DuPage Water Commission

AGENDA – Engineering and Construction Committee

X. **Resolution R-66-25:** A Resolution Awarding a Contract for the Construction of the West Transmission Main along Book Road from 75th Street to the ComEd R.O.W. (Contract TW-6/25 Section 1 (Book Road)) (**D. Construction, Inc. & Benchmark Construction Co., Inc. Joint Venture - $67,148,000)**

DUPAGE WATER COMMISSION
WATERLINK EXTENSION
CONTRACT TW-6/25 SECTION 1 WEST TRANSMISSION MAIN

DRAWING NO. MOT-004 | SHEET NO. 122 of 199

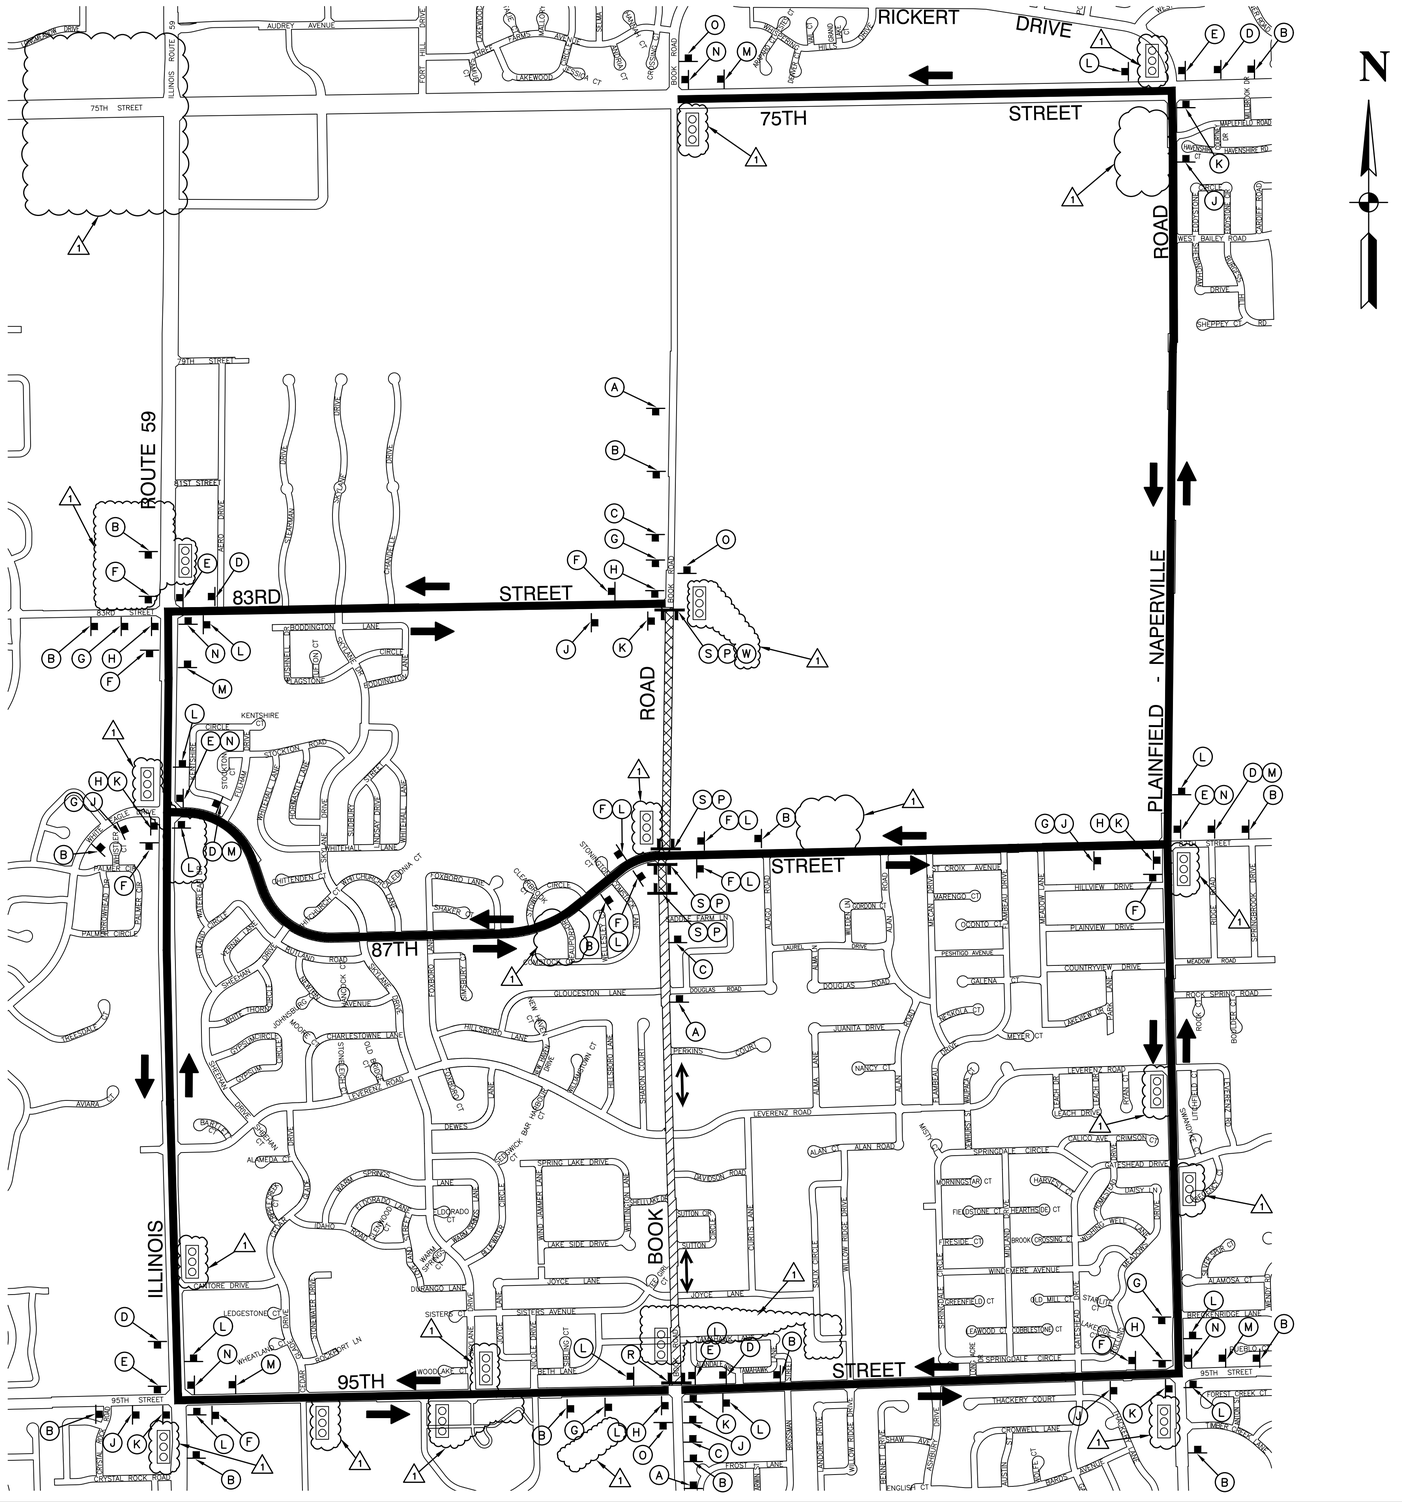
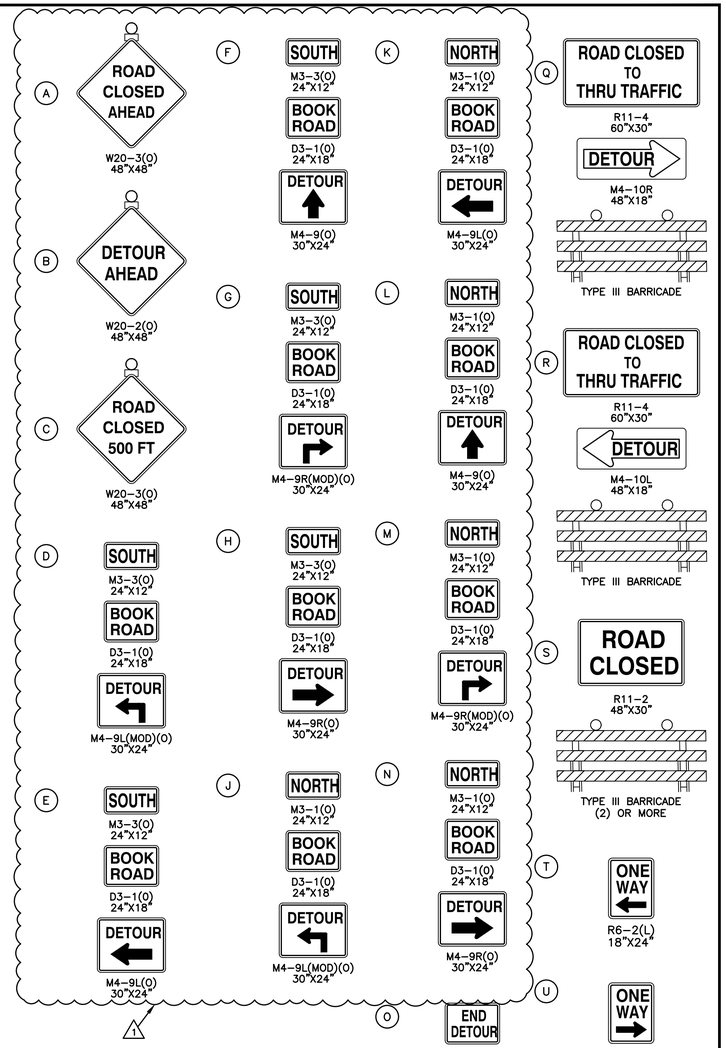
E. Replace Sheet 122 of 199 (Drawing MOT-004) to address comments from IDOT Permits for use of IL Route 59 for Detour Routes. Updated Sign Legends to clarify panels are Orange by adding (O) after sign codes. Added Additional Detour Signs "V" and "W" to sign legend. Added Legend Item to note Temporary Traffic Signal Timing locations to supplement Table on Sheet MOT-000. Revised Sign locations and types at various locations as clouded on the sheet.

SHEET NO. 123 of 199

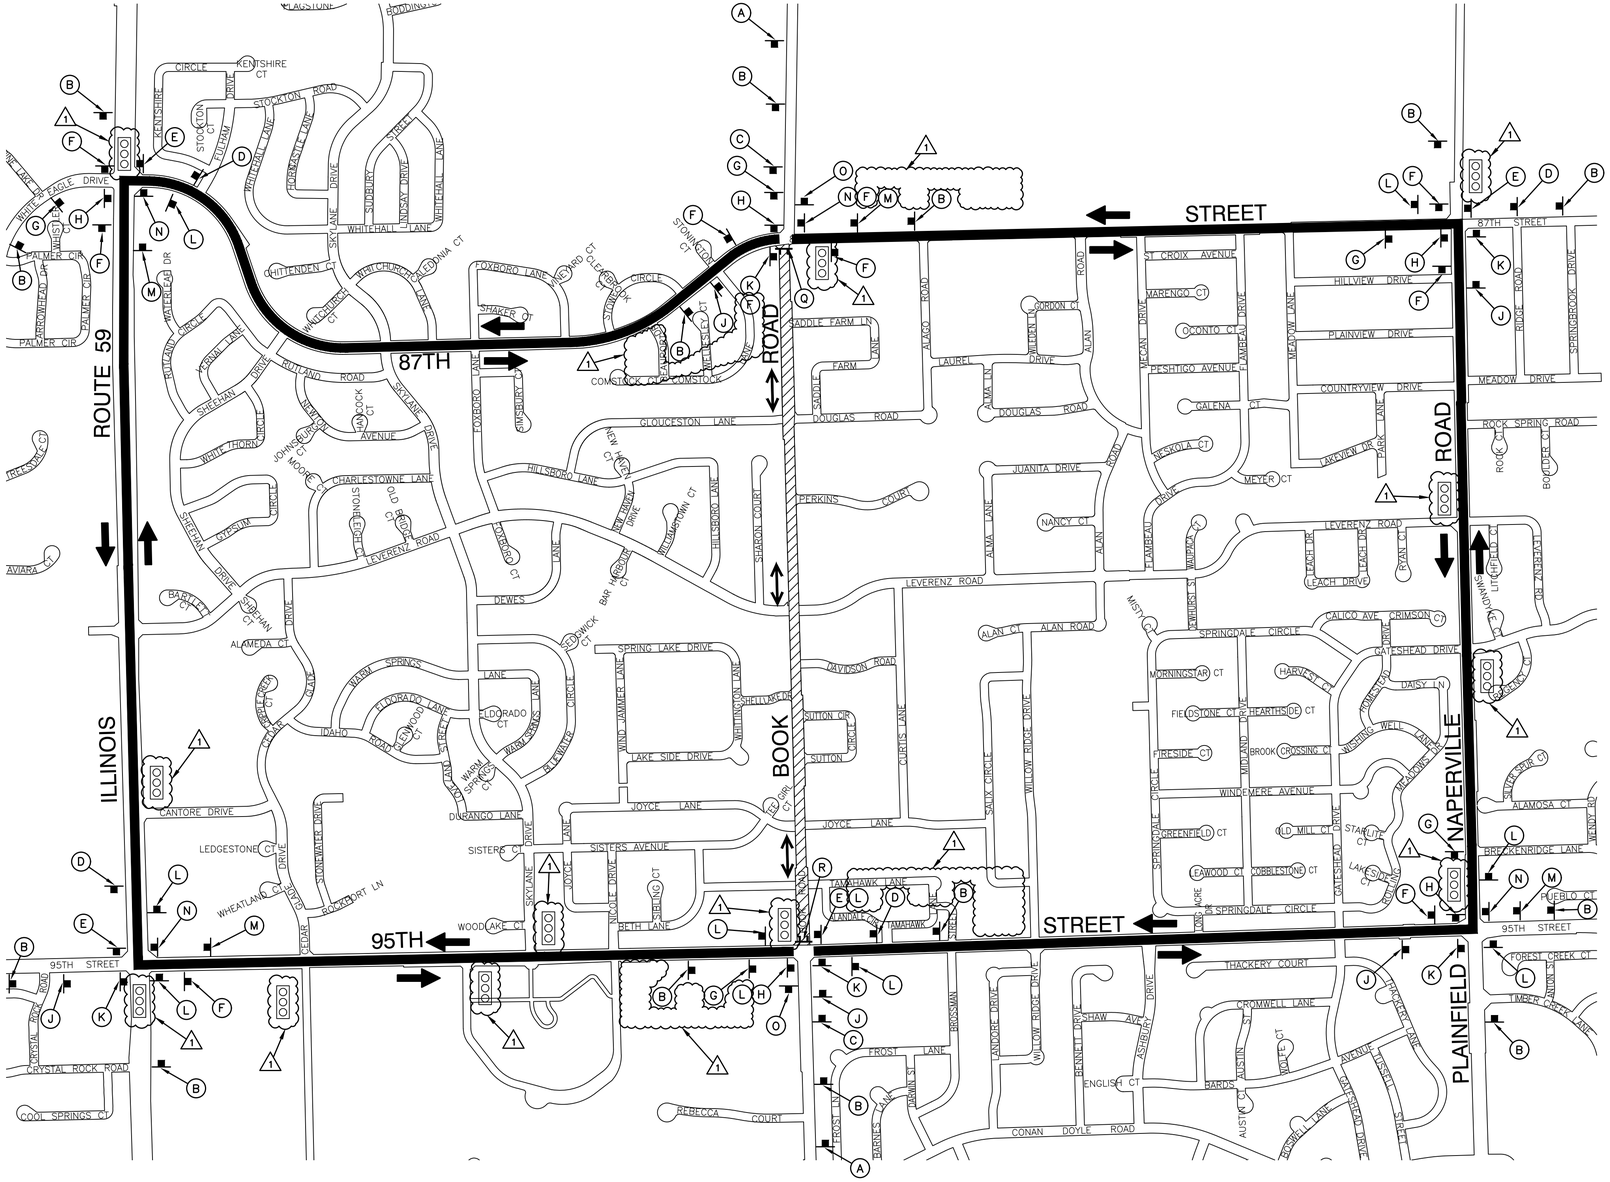
F. Replace Sheet 123 of 199 (Drawing MOT-005) to address comments from IDOT Permits for use of IL Route 59 for Detour Routes. Updated Sign Legends to clarify panels are Orange by adding (O) after sign codes. Added Additional Detour Signs "V" and "W" to sign legend. Added Legend Item to note Temporary Traffic Signal Timing locations to supplement Table on Sheet MOT-000. Revised Sign locations and types at various locations as clouded on the sheet.

DRAWING NO. MOT-006 | SHEET NO. 124 of 199

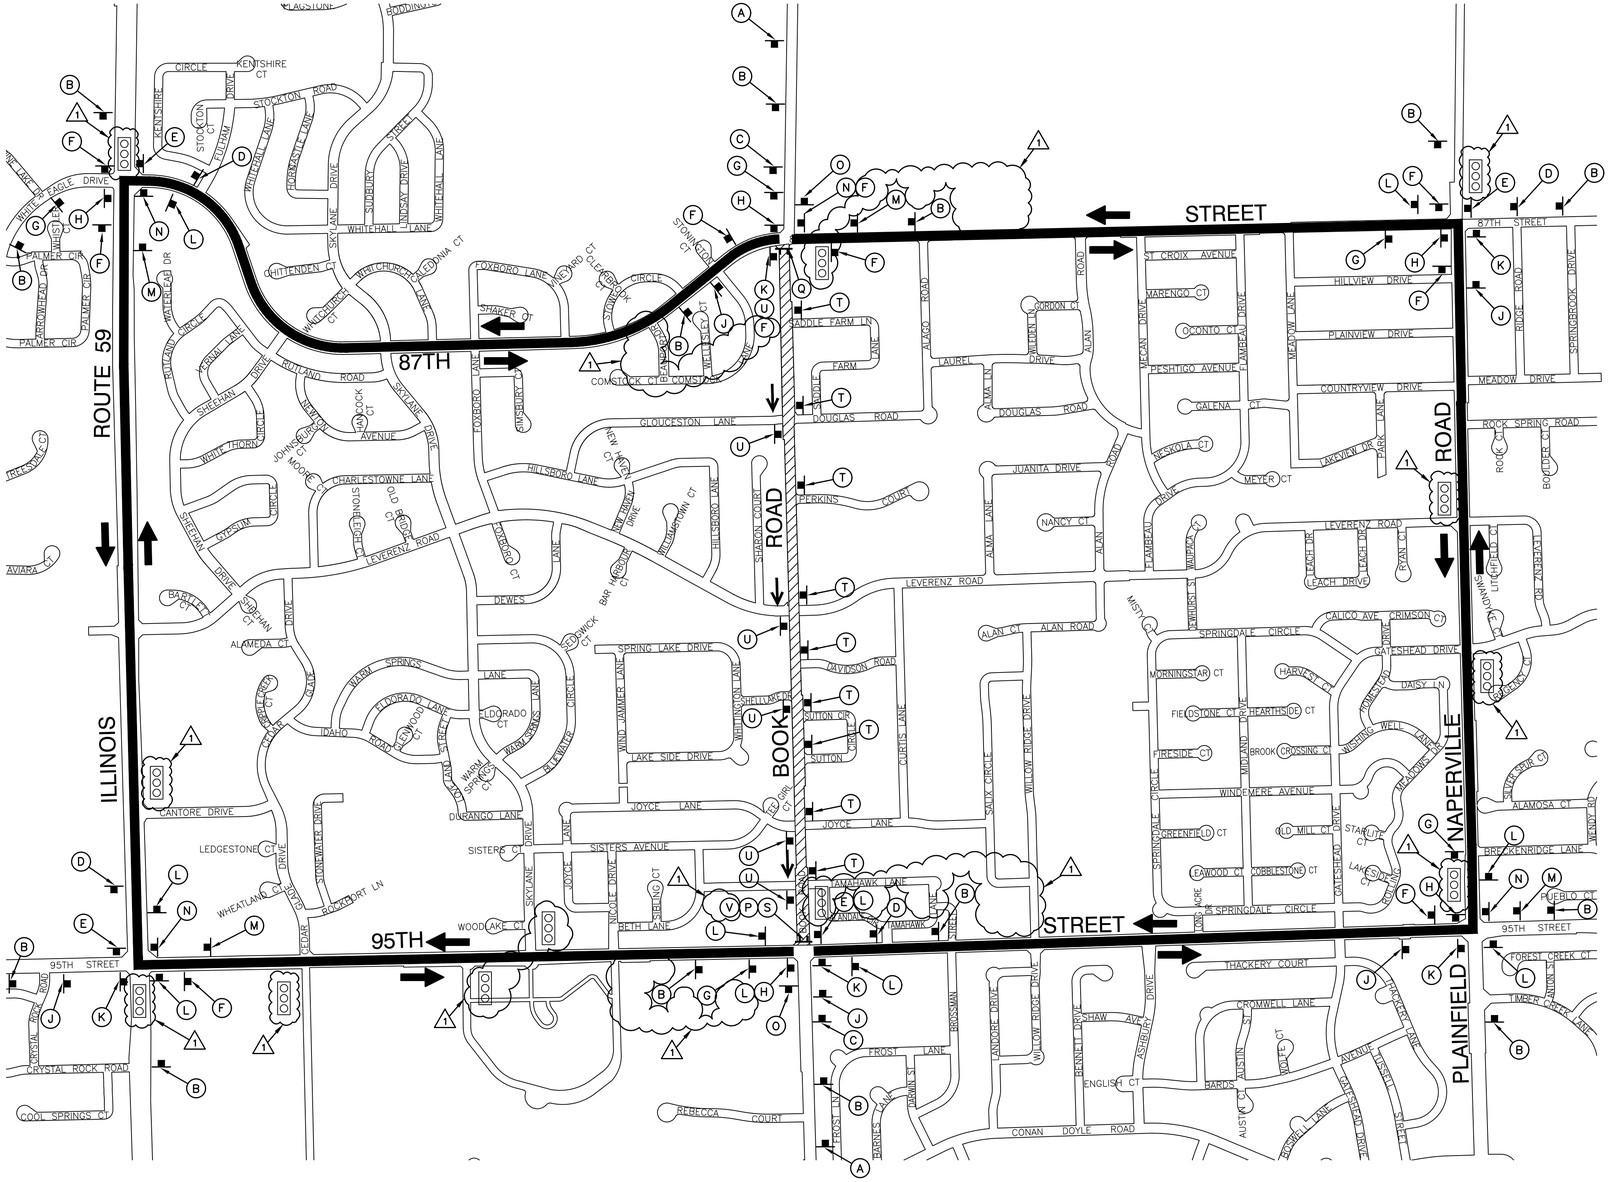
G. Replace Sheet 124 of 199 (Drawing MOT-006) to address comments from IDOT Permits for use of IL Route 59 for Detour Routes. Updated Sign Legends to clarify panels are Orange by adding (O) after sign codes. Added Additional Detour Signs "V" and "W" to sign legend. Added Legend Item to note Temporary Traffic Signal Timing locations to supplement Table on Sheet MOT-000. Revised Sign locations and types at various locations as clouded on the sheet.

DRAWING NO. MOT-007 | SHEET NO. 125 of 199

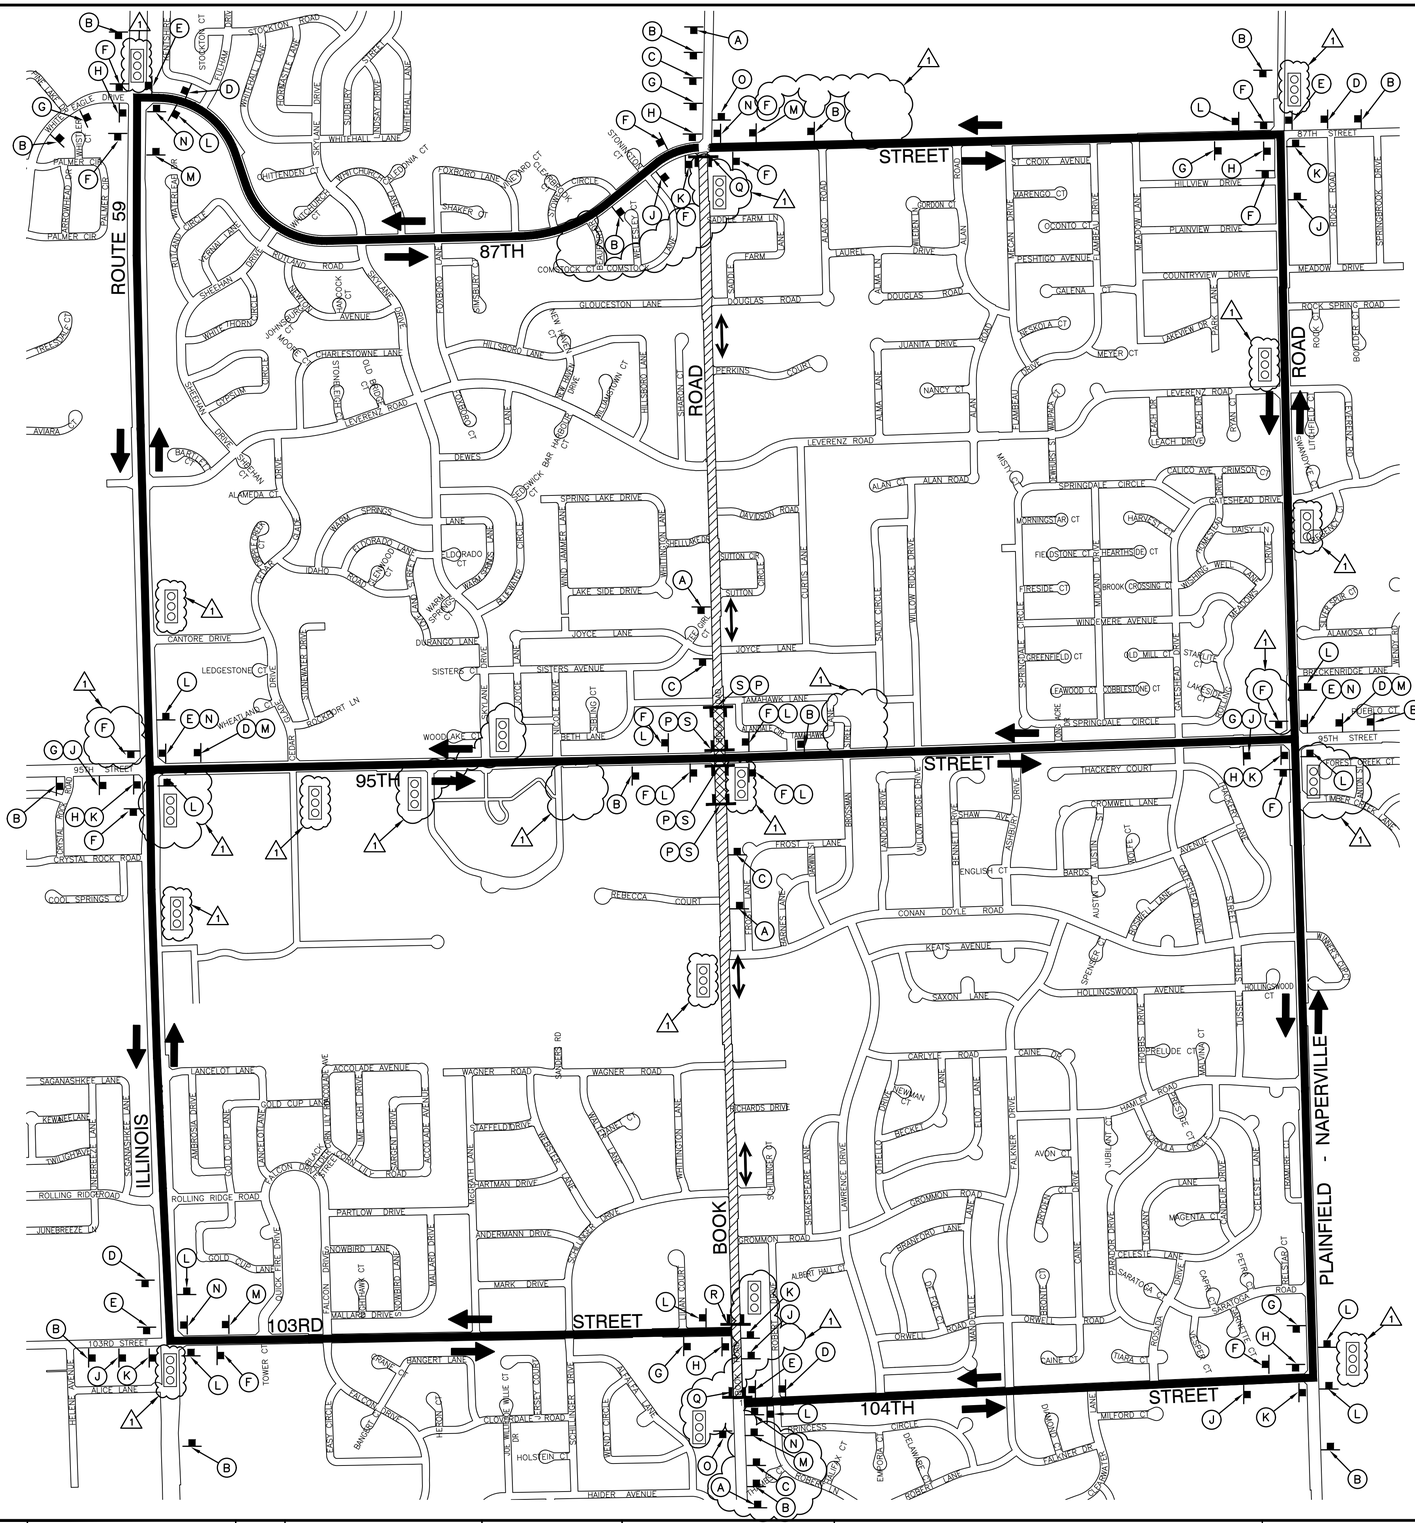
H. Replace Sheet 125 of 199 (Drawing MOT-007) to address comments from IDOT Permits for use of IL Route 59 for Detour Routes. Updated Sign Legends to clarify panels are Orange by adding (O) after sign codes. Added Additional Detour Signs "V" and "W" to sign legend. Added Legend Item to note Temporary Traffic Signal Timing locations to supplement Table on Sheet MOT-000. Revised Sign locations and types at various locations as clouded on the sheet.
